Re: Capstone Student Housing Zone 4
Transport Ave SE
Request Permanent C.O. - Accepted
Engineer's Stamp dated: 12-13-13 (M15D026)
Certification dated: 9-29-14

Re: Capstone Student Housing Zone 1 Residential and Clubhouse
3003 Transport SE
Request for Permanent C.O. –Accepted for residential units and 60-day
Temp CO for the clubhouse
Engineer's Stamp dated: 10-8-13, (M15D026)
Certification dated: 8-14-14

Re: Zone 3 Grading Plan, Engineer's Stamp Date 12-03-2013
Zone 4 Grading Plan, Engineer's Stamp Date 12-13-2013 (M-15/D026)

CAPSTONE STUDENT HOUSING ALBUQUERQUE, NM	DRAWN BY SH
	ZONE 3 DETAILED GRADING PLAN	DATE 8-28-13
<p>JEFFREY T. WOOTEN P.E. #16892</p>	<p>TIERRA WEST, LLC</p> <p>5571 MIDWAY PARK PL. NE ALBUQUERQUE, NEW MEXICO 87109 (505) 858-3100 www.tierrawestllc.com</p>	DRAWING 2011064-GR
		SHEET # C5E
		JOB # 2011064

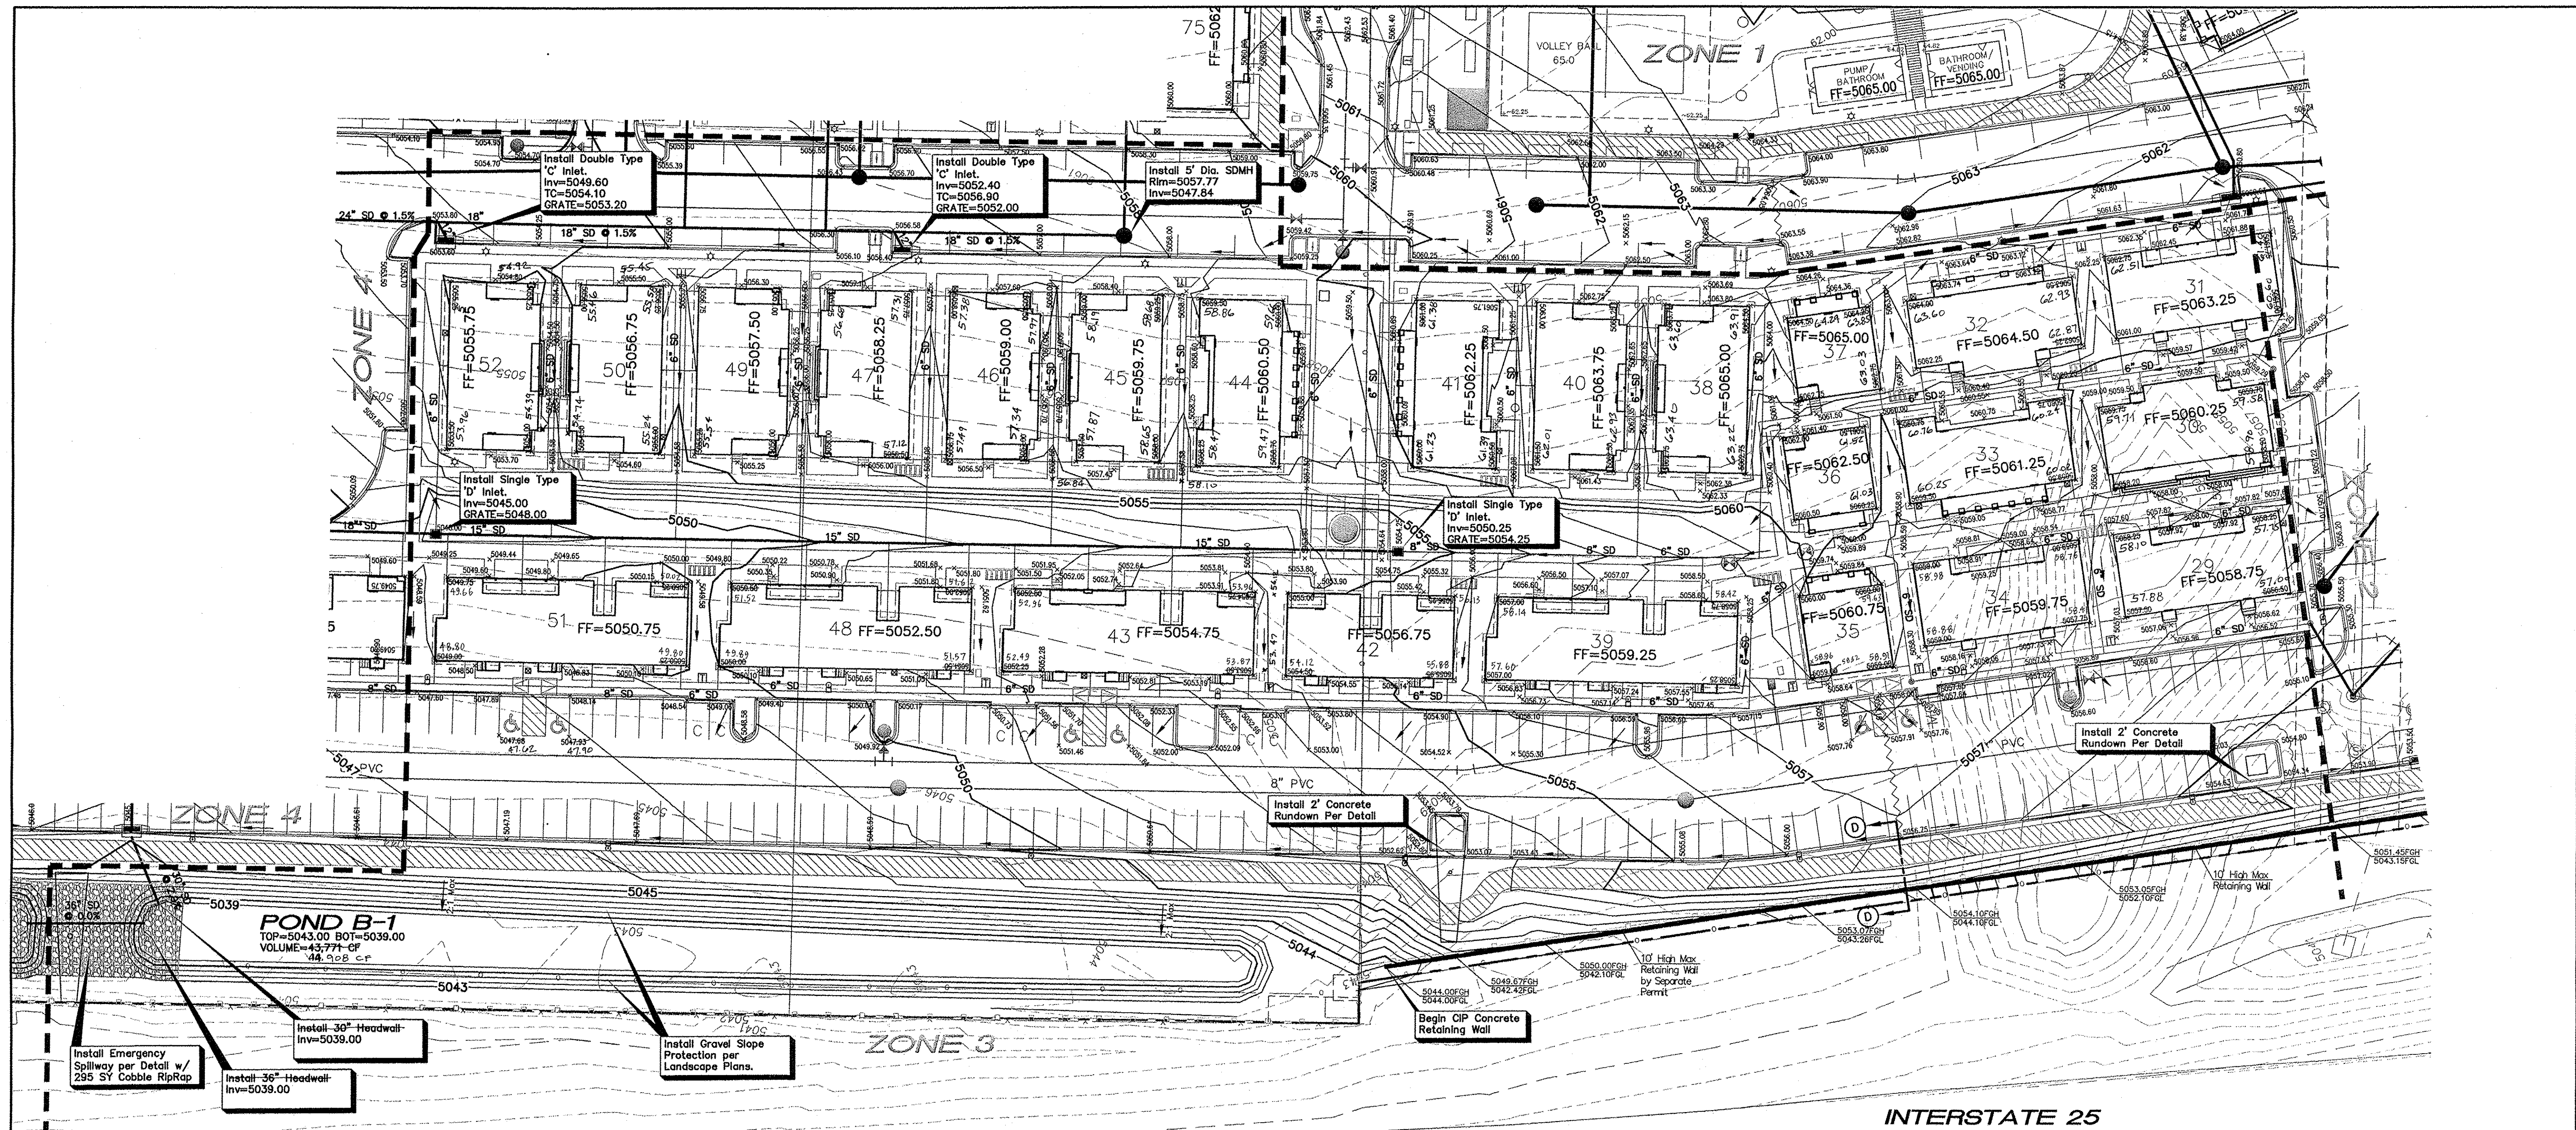
Based the Zone 3 and 4 Grading plan in your submittal received 12-03-13 and 12-13-2013 the project is approved for Building Permit for buildings 29 through 52 (under Zone 3) and buildings 53 through 75 (under Zone 4) based on the following conditions:

- 30" headerwall should be change to 36" headerwall for the 36" storm drain pipe connecting Pond B-2 to Pond B-3.
- When providing as-built drawings, please provide all inlet numbers, inlet/mh/storm drain pipe inverts, inlet top of curb and grate elevations, and all the storm drain pipes slopes and normal flow depths.
- As-built pond volumes should be provided.
